**PLANNING BOARD AGENDA**

**APRIL 13, 2026  
REGULAR MEETING**

Re: **Zoning Board Application**  
**1817 Pine Terrace**  
**Block 15, Lot 8**  
**Our File LCPB 26-02**

**Re: Completeness Review #2  
Tonero Variance Application  
1817 Pine Terrace  
Block 15, Lot 8  
H2M Project No. LKCP2510**

**New Single Family Home Site & Grading Plan**  
**JOHN & DEIRDRE TONERO**  
**1817 PINE TERRACE**  
 Tax Lot 8 - Block 15  
 Borough of Lake Como  
 Monmouth County, New Jersey

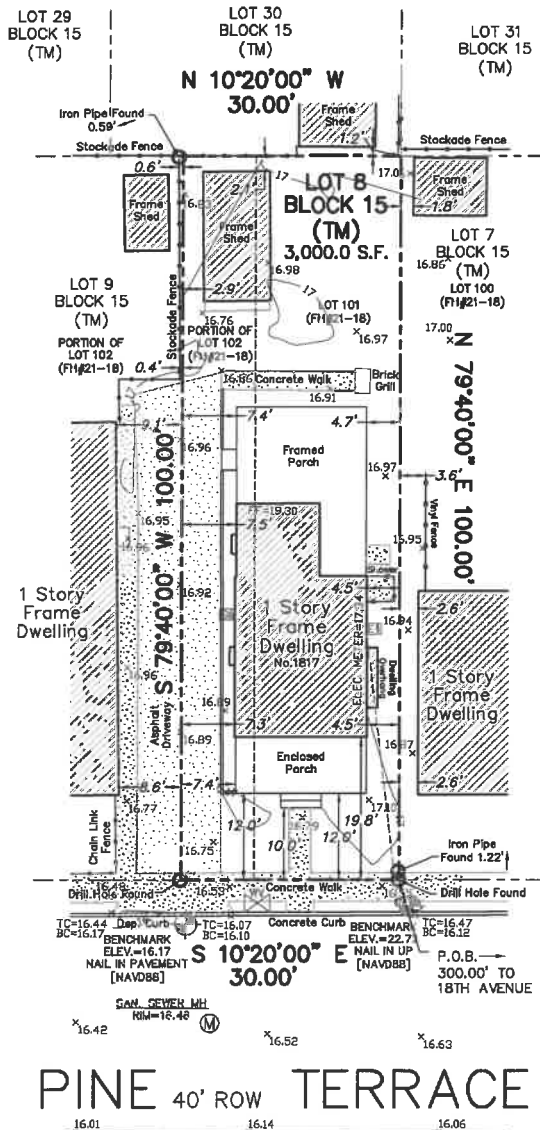
- A. The Applicant does not propose any drainage improvements. Additional grading and drainage information is required to determine compliance with Ordinance 2024-01, or request a waiver from the Board.
- B. No roof leaders are shown on the application plans or the property survey. The Applicant sh demonstrate how runoff from the proposed dwelling, porch, and patio will be collected and discharged, and whether any dry wells or other BMPs are proposed.

- A. The Applicant shall testify to the elevation of the slab. A floor slab shall be a minimum of two (2) feet above the seasonal high water table.
- B. The Applicant shall testify to the height of the proposed shed.

- The Applicant has provided a Site Plan and a recent survey. However, both of these documents do not scale appropriately and listed dimensions are not reproducible. A revised Site Plan and survey must be provided with an acceptable scale.
